TENDER 18-13

WATERFRONT SEWER UPGRADES PHASE I

ADDENDUM NO. 5

May 24th, 2018

Cast - In - Place Detail

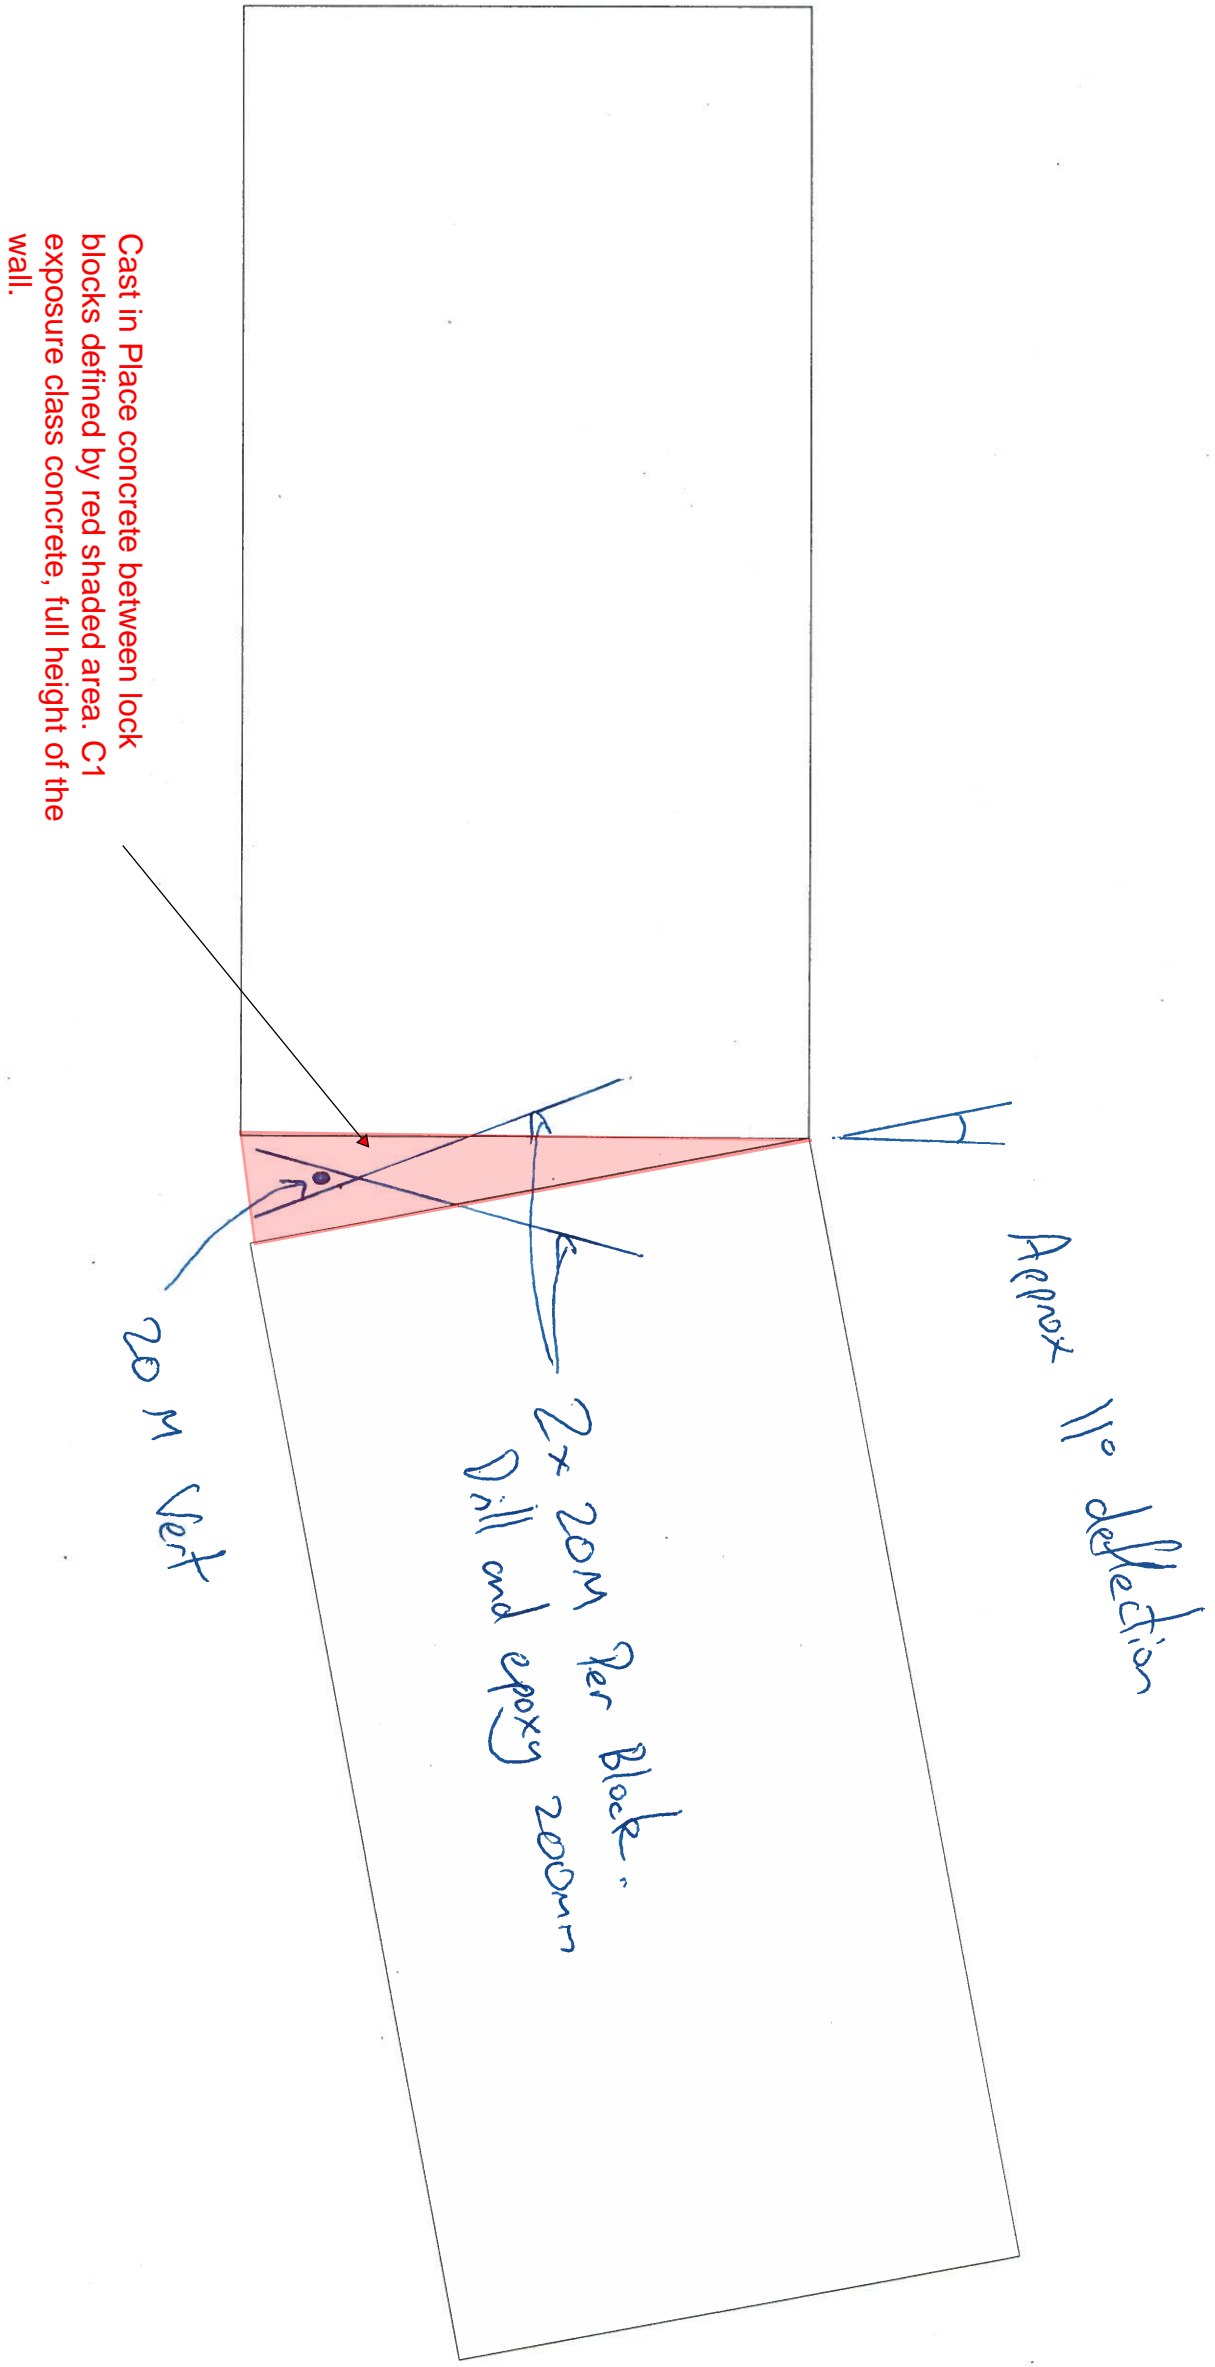
The sketch provided in addendum 3 indicates the connection between lock kblocks. Can you please provide the transition from the cast in place to the lock-block. The cast in place wall is only 12 inches thick.

See attached sketch.
